Product Highlights

Change Notice

PCN No: 144

PCN No: 125

Product Type: AL295

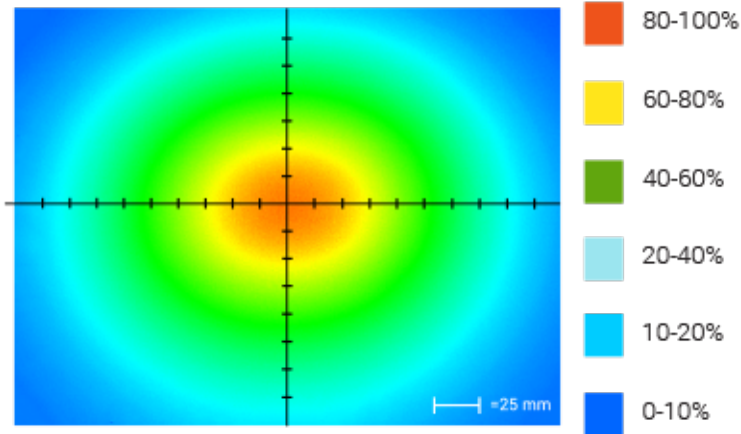
In an effort to improve our products, Advanced illumination (Ai) will update the LEDs used in the AL295 design. This change will result in a brighter, more uniform light at the same price*. Customers may still buy the current revision of this model until September 2th of 2016. After that time, orders for these products will be converted to their respective AL295 Revision A models.

This LED change will result in additional wavelengths being available: 365nm, 375nm, 385nm, 395nm, 405nm, 470nm, 505nm, 590nm, 660nm, 730nm, and 940nm. Additionally the white LED color temperture will be changing from 6100K to 5500K.

*UV wavelengths (365nm, 375nm, 385nm, 395nm & 405nm) will be sold a higher list price, which will be released at the time of product introduction.

Orders for customized (dash numbers) versions of AL295 will be honored until January 13th of 2017. Ai will be actively working with customers for those products to simplify the transition.
